**ARLINGTON COUNTY, VIRGINIA
OFFICE OF THE PURCHASING AGENT**

INVITATION TO BID NO. 23-DES-ITBPW-453

ADDENDUM NO. 1

Arlington County Invitation to Bid No. 23-DES-ITBPW-453 for Underground Detention Tank/Vault Inspection & Maintenance at Cardinal Elementary School is amended as follows:

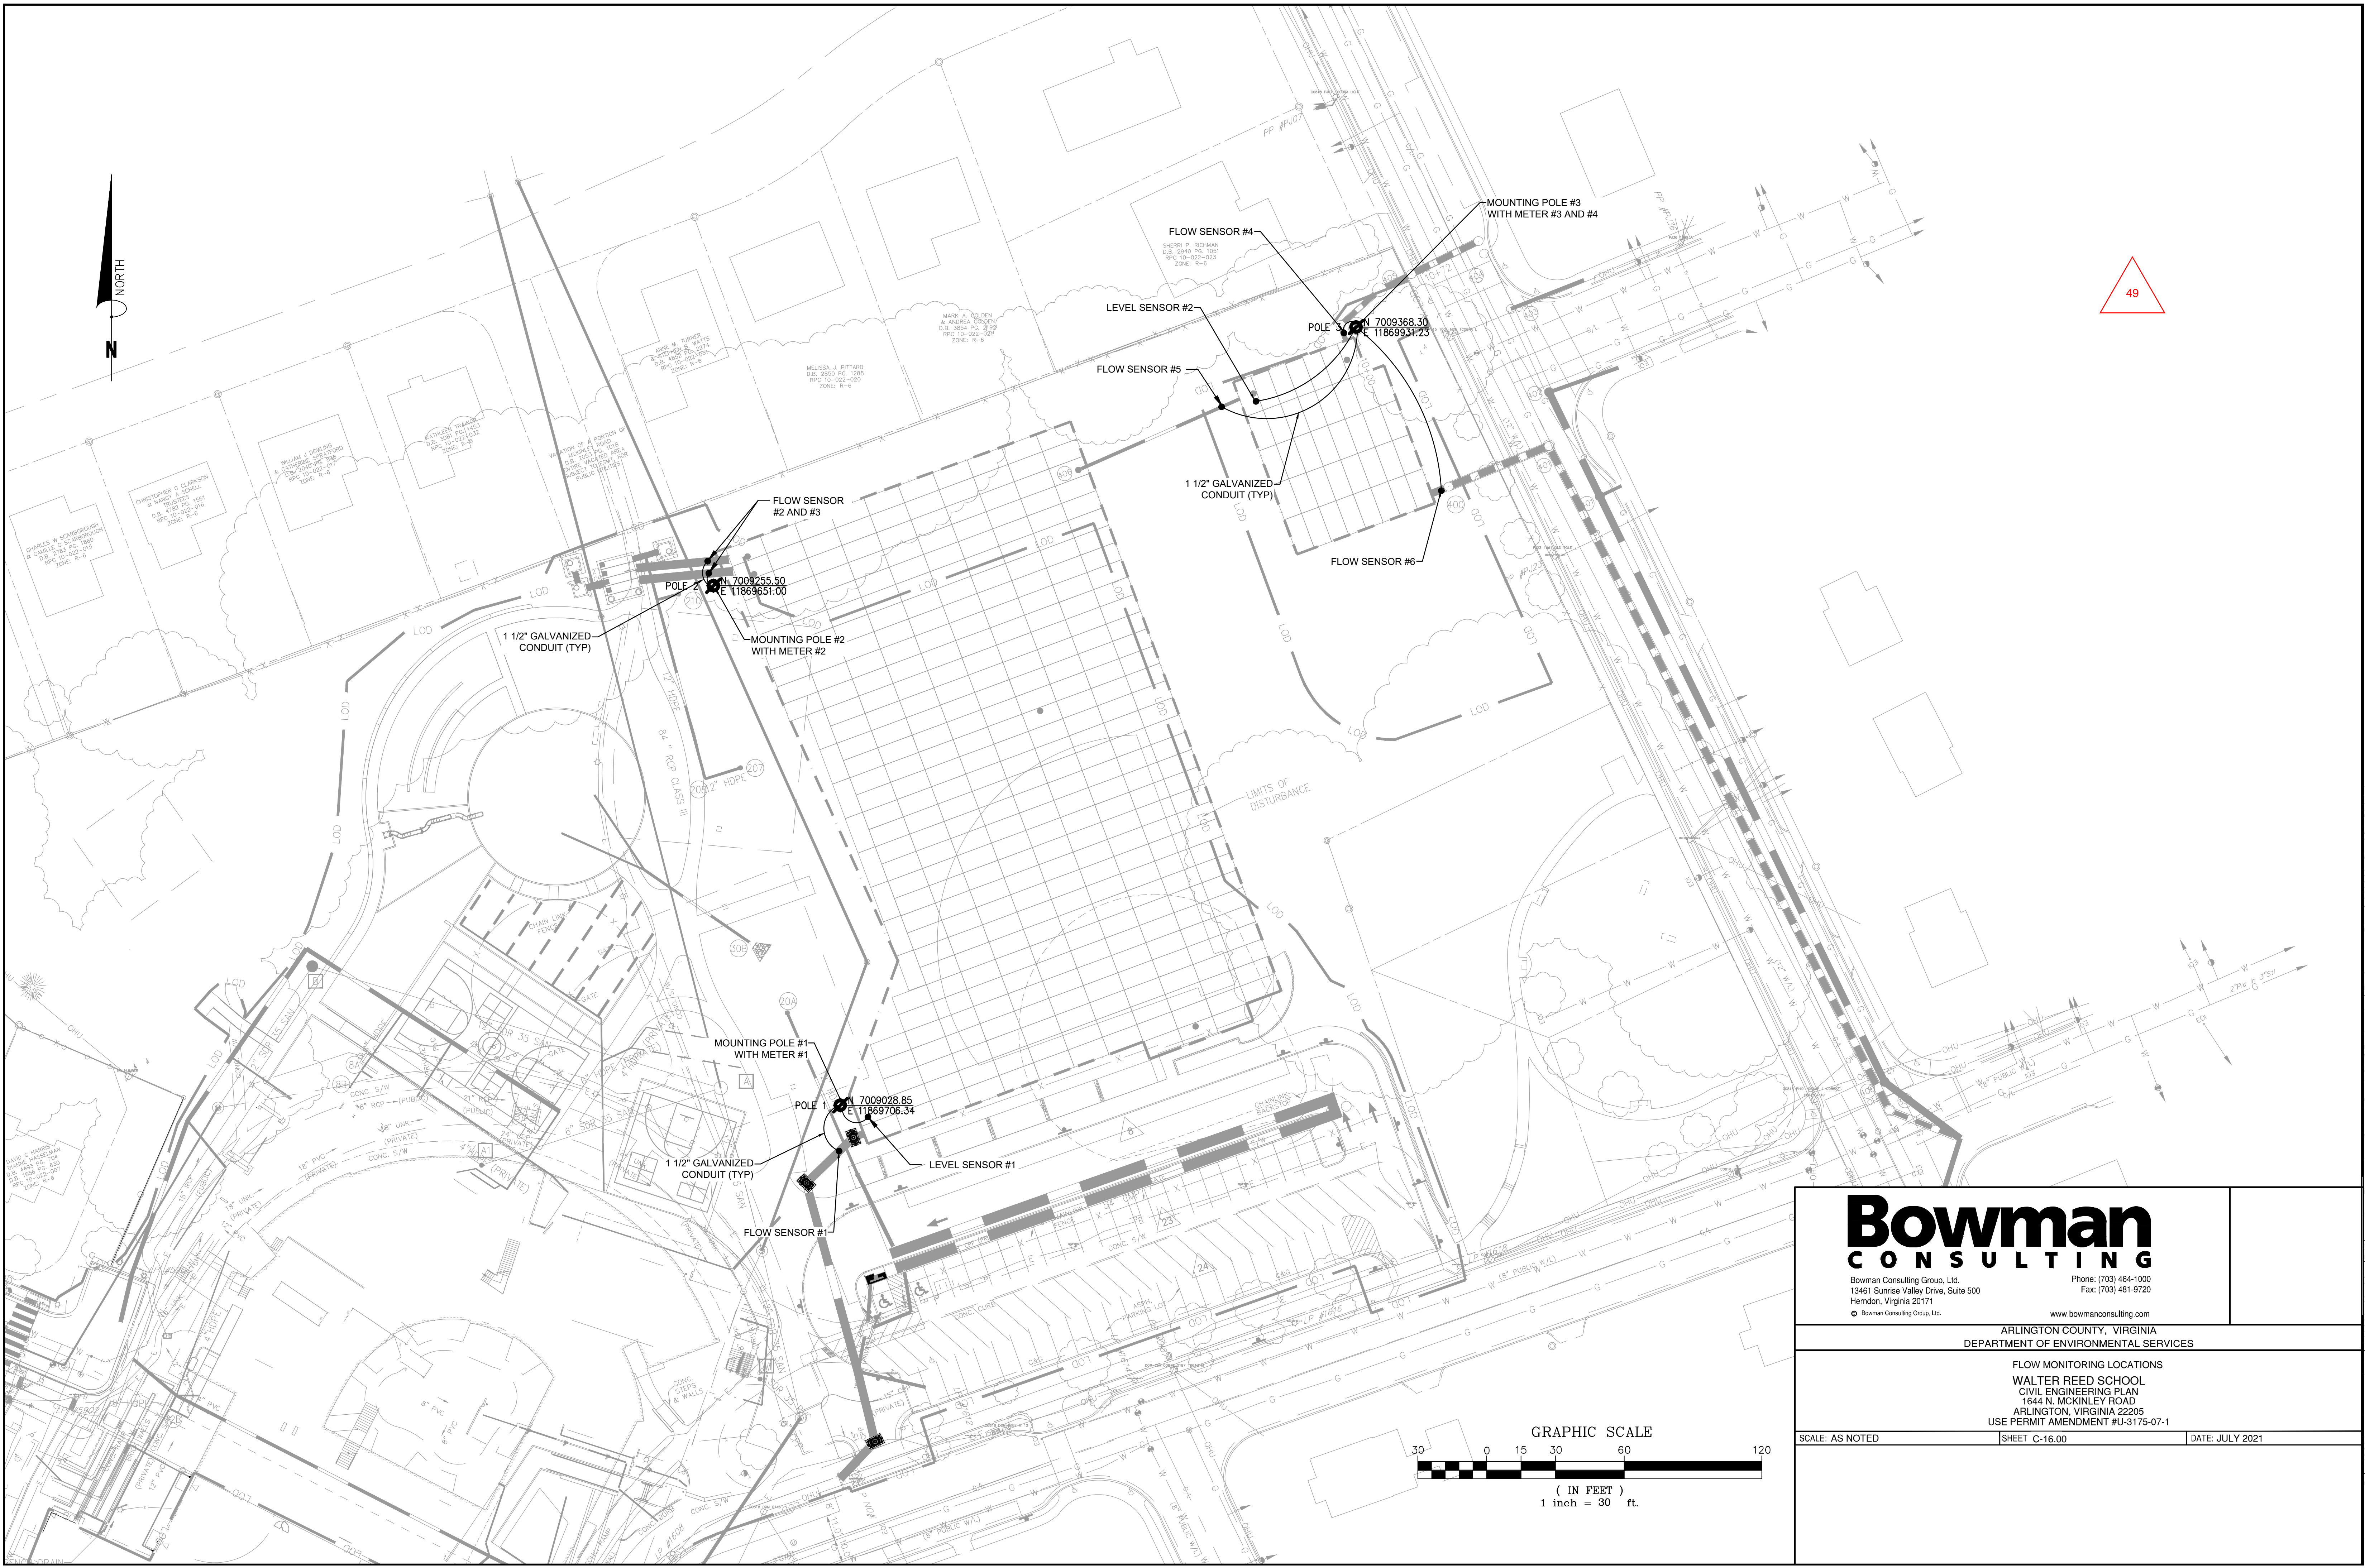
Question 2: Under qualification you list Flow Monitoring sensors, please elaborate the need for these as it pertains to this particular work if possible.

Answer 2: The Contractor shall be aware of the locations of Flow Monitoring sensors and ensure that they are not damaged during inspection and maintenance activities. The Contractor must be able to replace components of the Flow Monitoring system should they be damaged, either from typical operation of the vault system, or during inspection and maintenance activities. Refer to plan entitled Flow Monitoring Locations included as an Attachment to this Addendum 1 for additional information.

SHEET TITLE
SITE PLAN

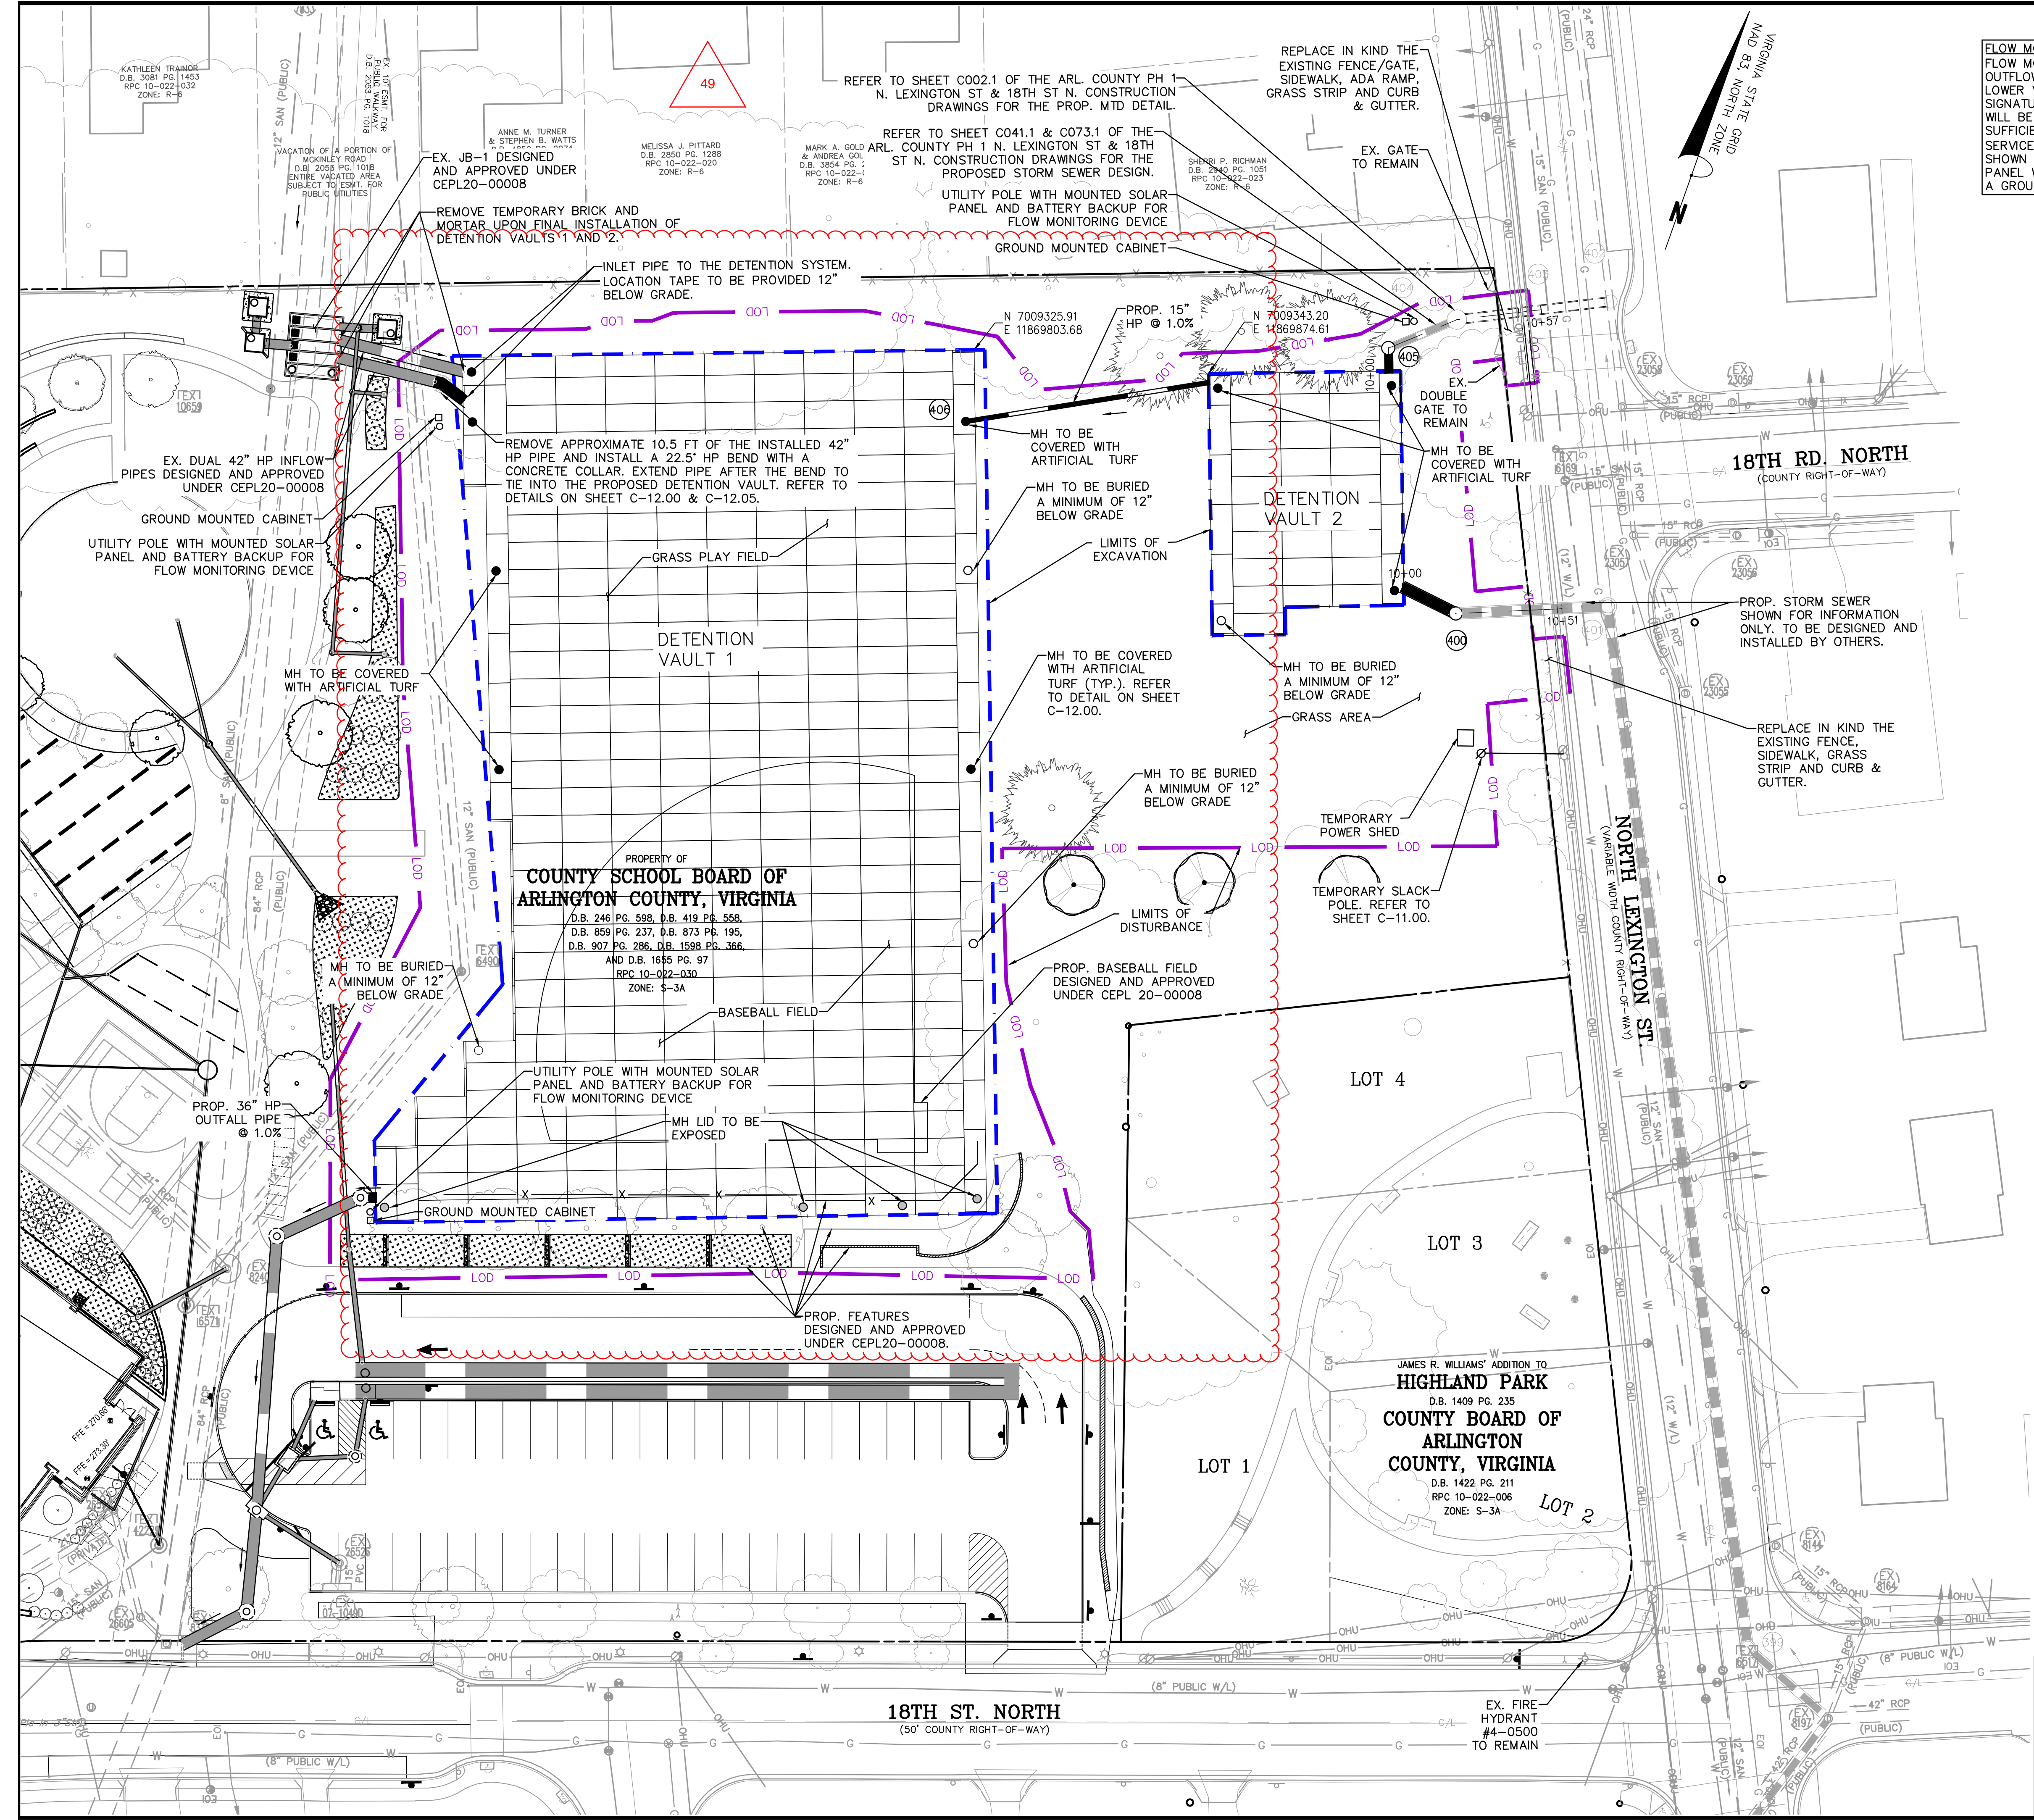
Question 3: Item 17 states that the bidder is responsible for investigating the workload, conditions, factors affecting costs. Will plans be available for review? With this work residing at an elementary school, do we need to coordinate a site visit to assess the conditions?

Answer 3: The vault is currently under construction; however, bidders can go to the adjacent public park to see the site. The links below will provide more information than a site visit could provide.

Please see the Site Plan and Suggested Maintenance Plan included as attachments to this Addendum 1 for your reference.
